FILE NAME c:\pwworking\jacobs_b&lpw-r\mandgrld0321956\C9424_PS_DR26.dgn										REGION NO. STATE		FED.AID PROJ.NO.			PRELIMINARY	NOT FOR CONSTRUCTION		SR509 I-5 TO 24TH AVENUE S NEW EXPRESSWAY		PLAN REF NO	
TIME 5:34:53 PM								DR26													
DATE 12/16/2021																					
PLOTTED BY GlennR						JOB NUMBER														SHEET	
DESIGNED BY T. STANLEY						CONTRACT NO. C9424		LOCATION NO.												OF SHEETS	
ENTERED BY N. KLYZHKO																					
CHECKED BY S. MESIC		REV B - FINAL REVIEW		12/03/21																	
PROJ. ENGR. A. CHEPEL		REV A - PRELIMINARY REVIEW		7/23/21																	
REGIONAL ADM. J. WHITE		REVISION		DATE		BY

FILE NAME c:\pwworking\jacobs_b&lpw-rlmandgrd0321956\C9424_PS_DR28.dgn										<div></div> <div>PRELIMINARY</div> <div>NOT FOR CONSTRUCTION</div>		<div></div> <div>Washington State Department of Transportation</div>		SR509 I-5 TO 24TH AVENUE S NEW EXPRESSWAY		PLAN REF NO DR28
TIME 5:35:13 PM				REGION NO. 10	STATE WASH	FED.AID PROJ.NO.						SHEET				
DATE 12/16/2021				JOB NUMBER								OF				
PLOTTED BY GlennR				CONTRACT NO. C9424		LOCATION NO.						SHEETS				
DESIGNED BY T. STANLEY																
ENTERED BY N. KLYZHKO

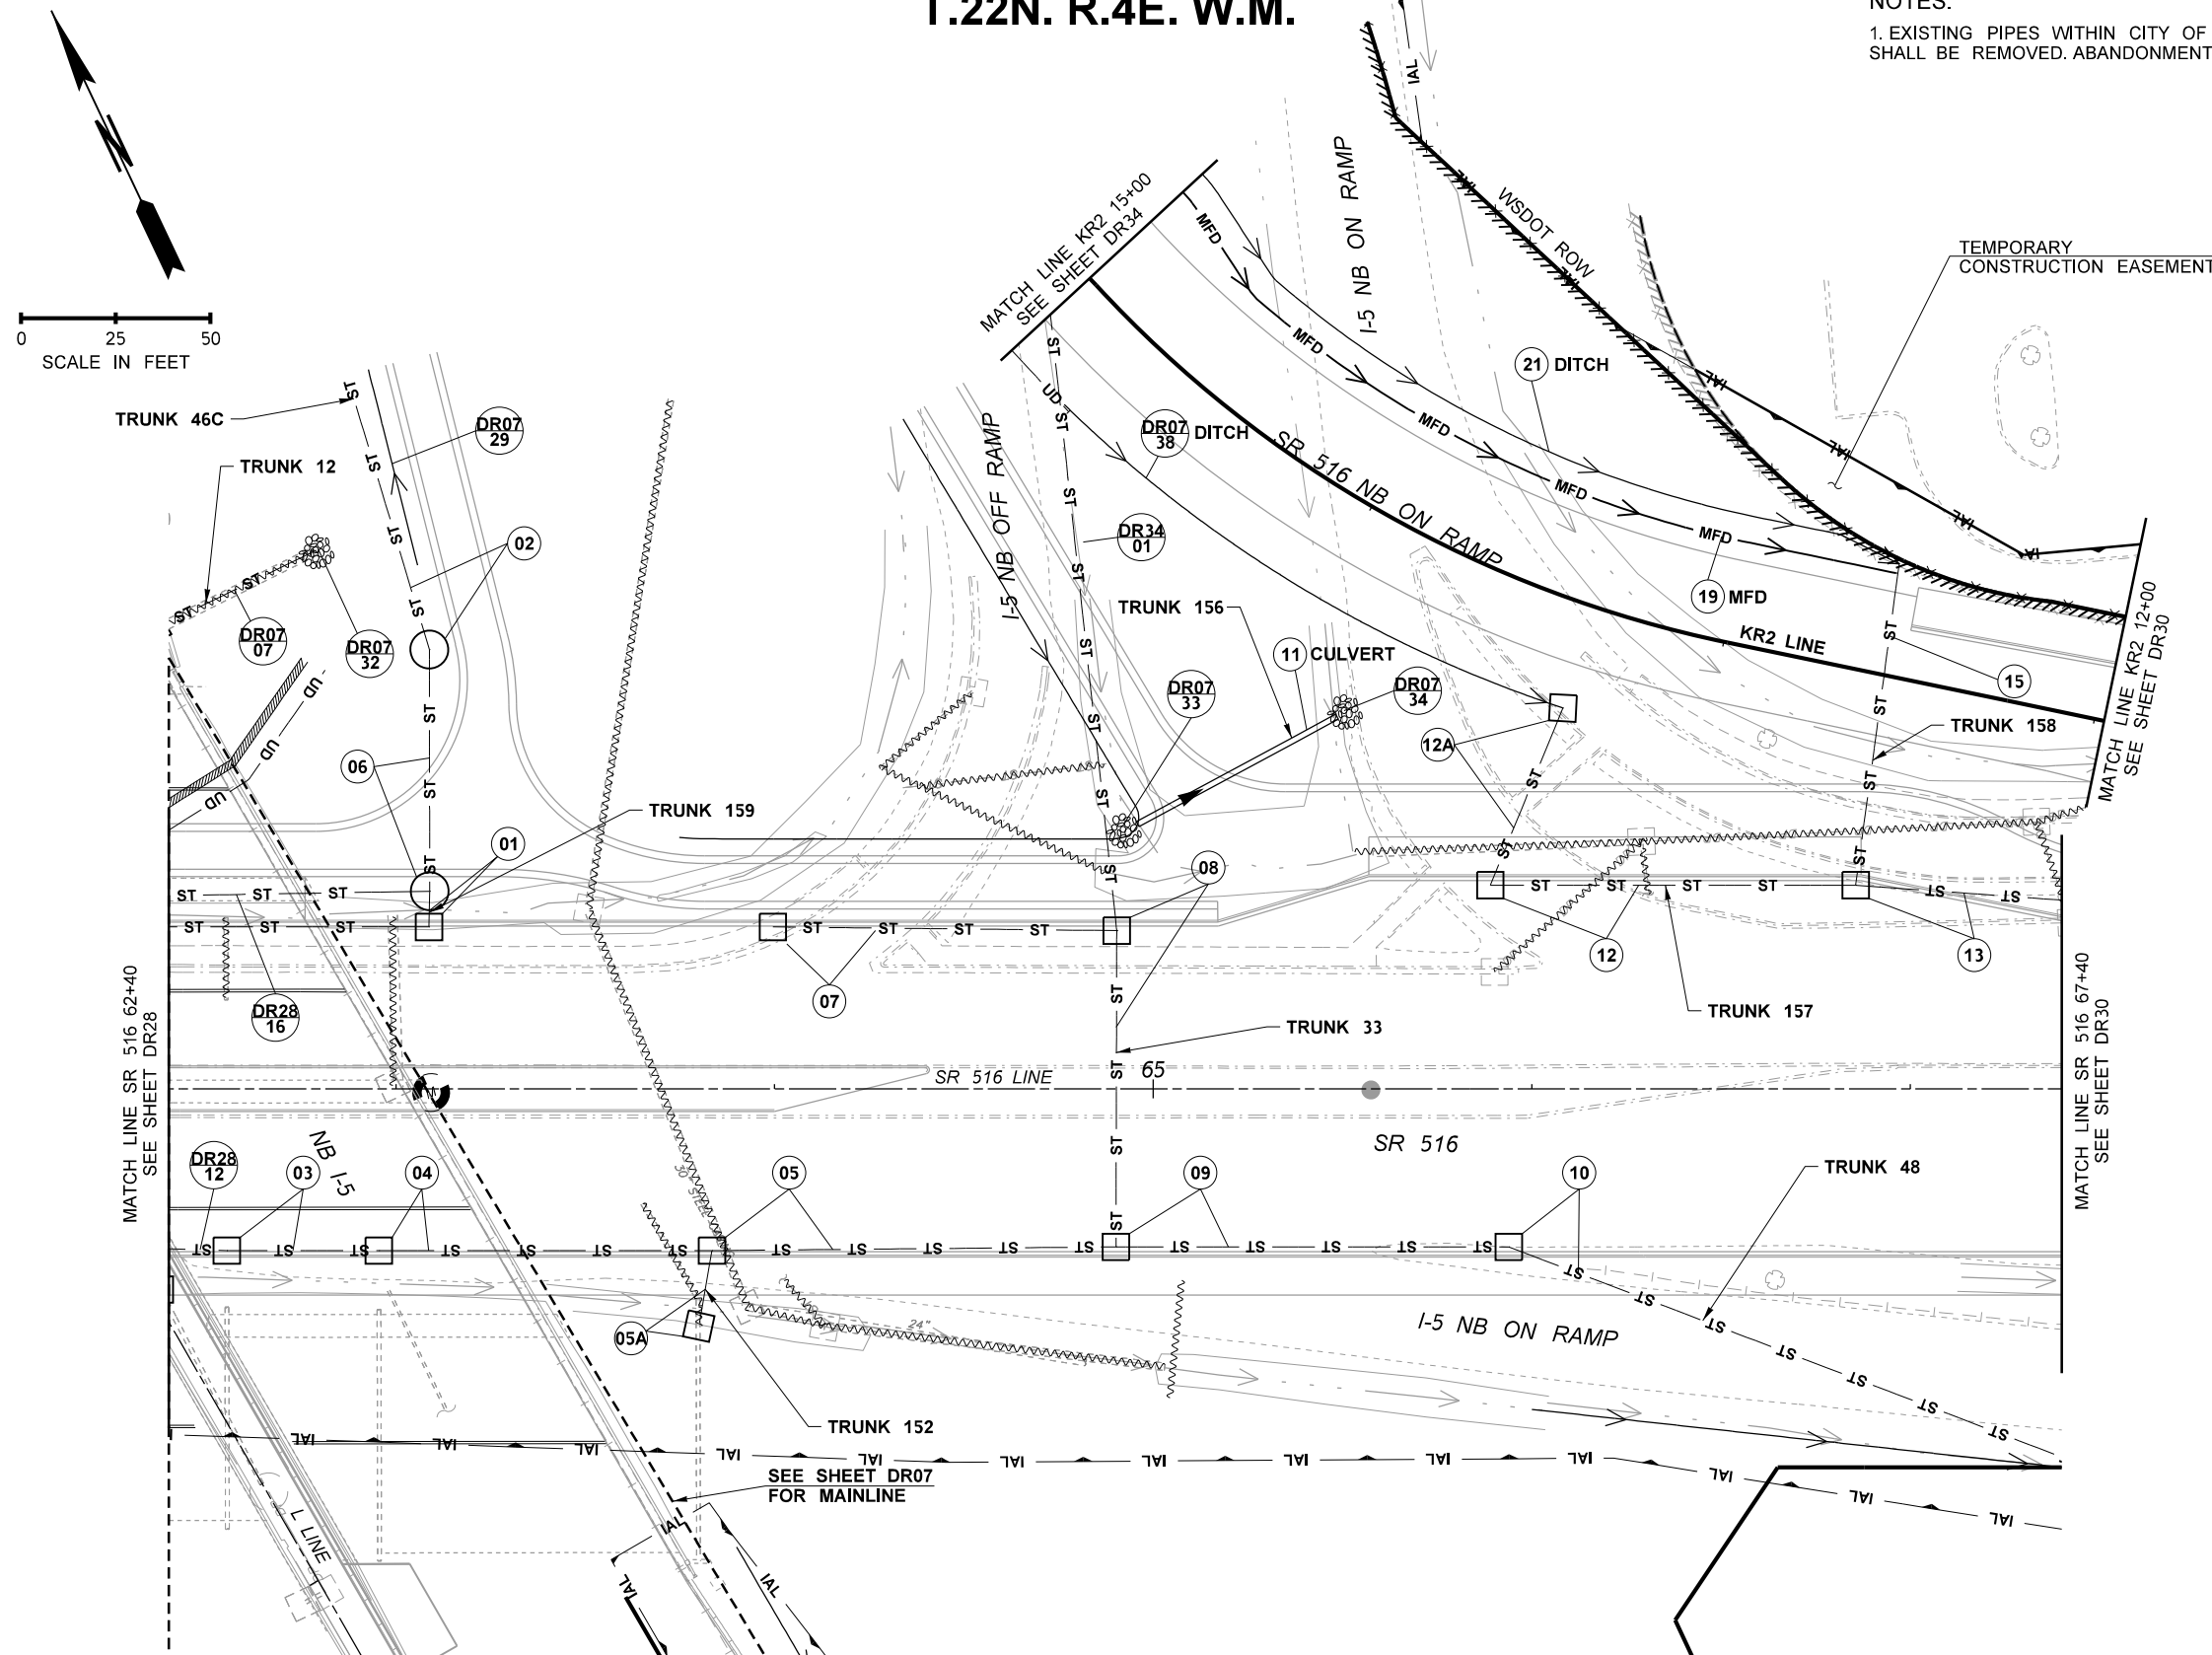
General Comment: Show ownership and maintenance responsibility of all storm pipes and structures

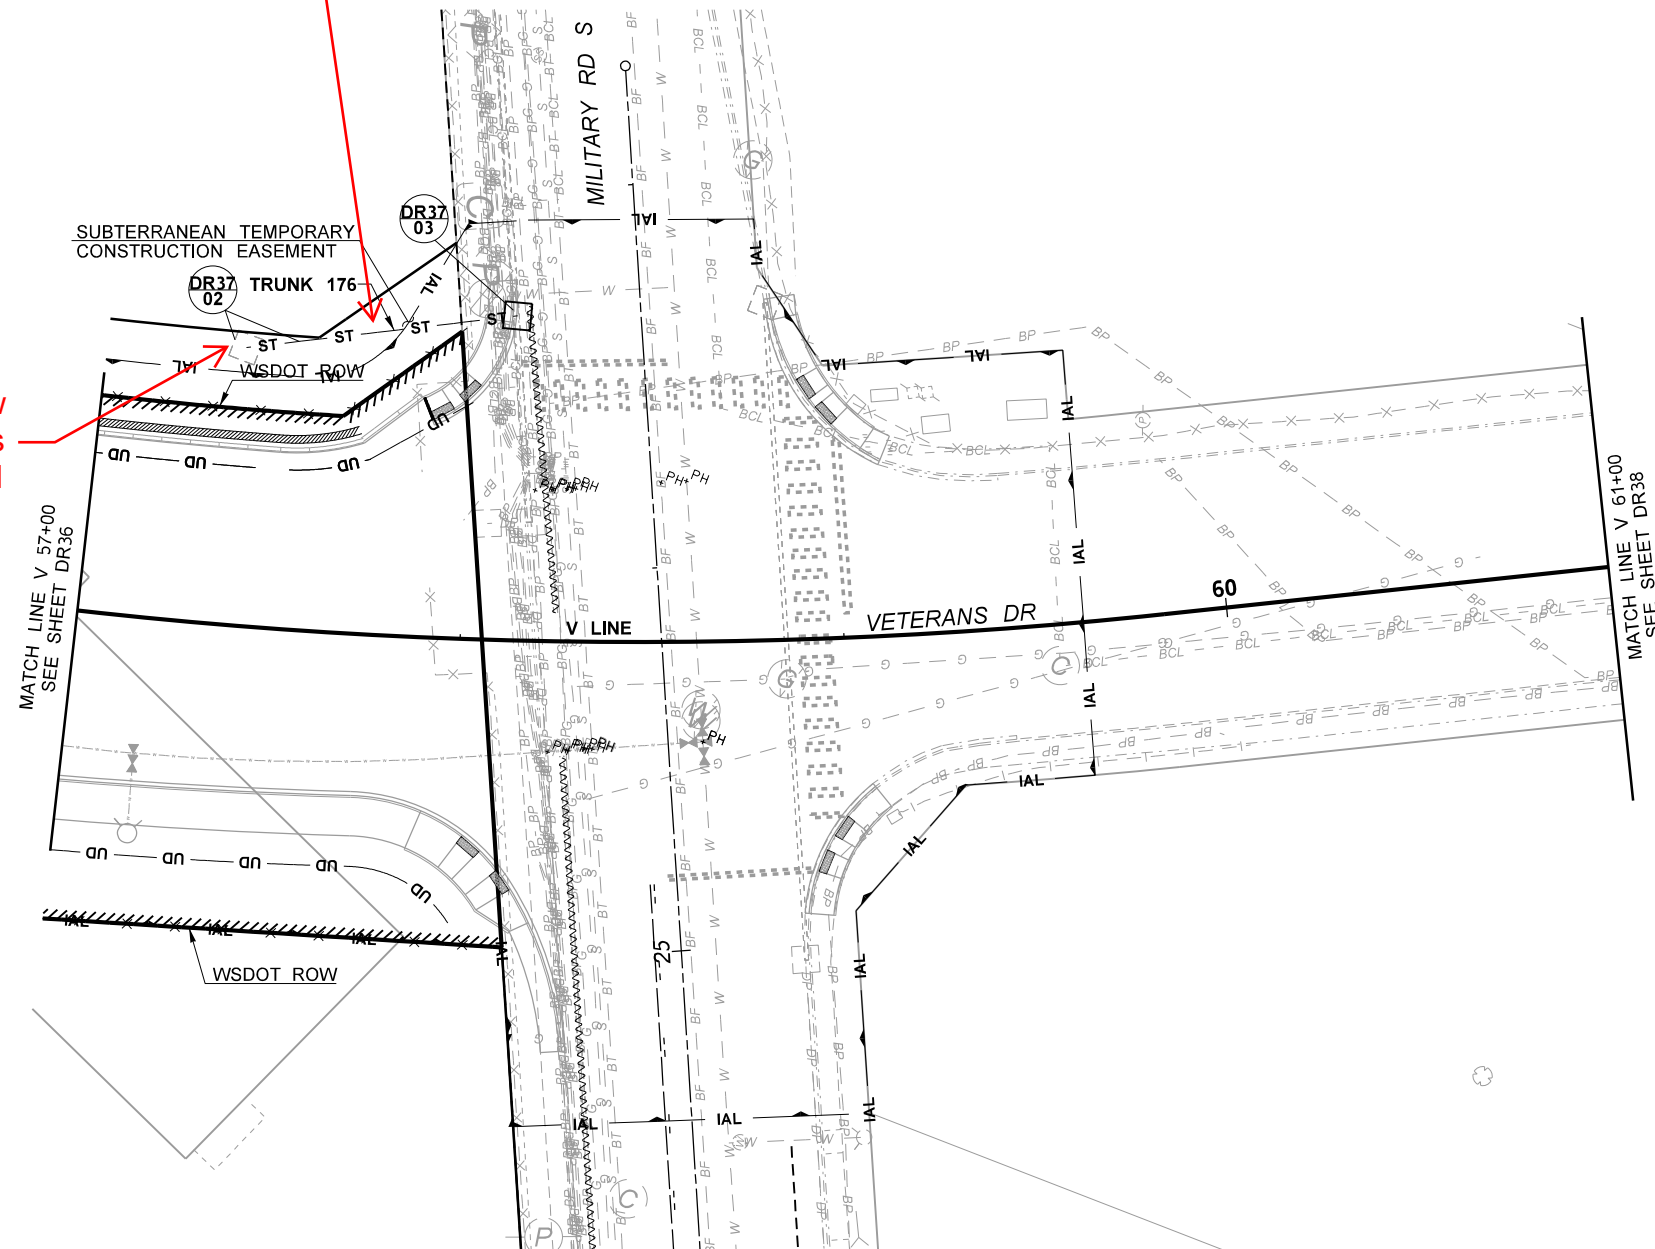
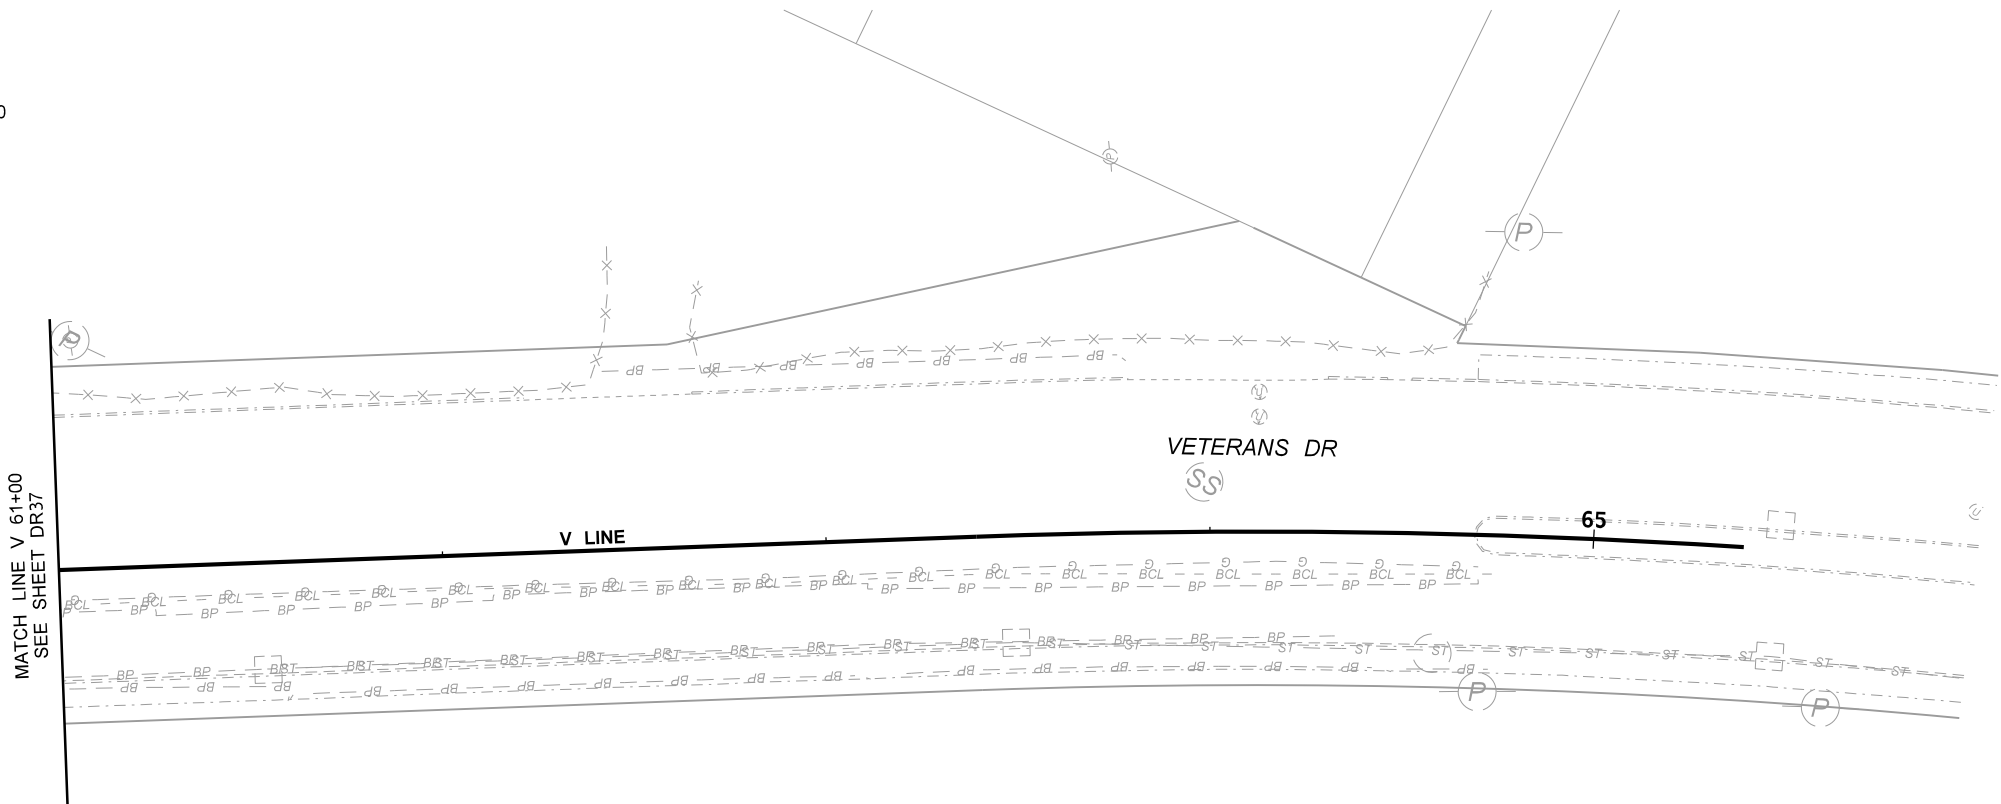
Show ownership and maintenance responsibility

This work is occurring on private property and requires a separate permit from the City of Kent. The permit shall show how the Poulsbo RV site is being restored as well as the drainage analysis, resulting detention and conveyance to reconnect
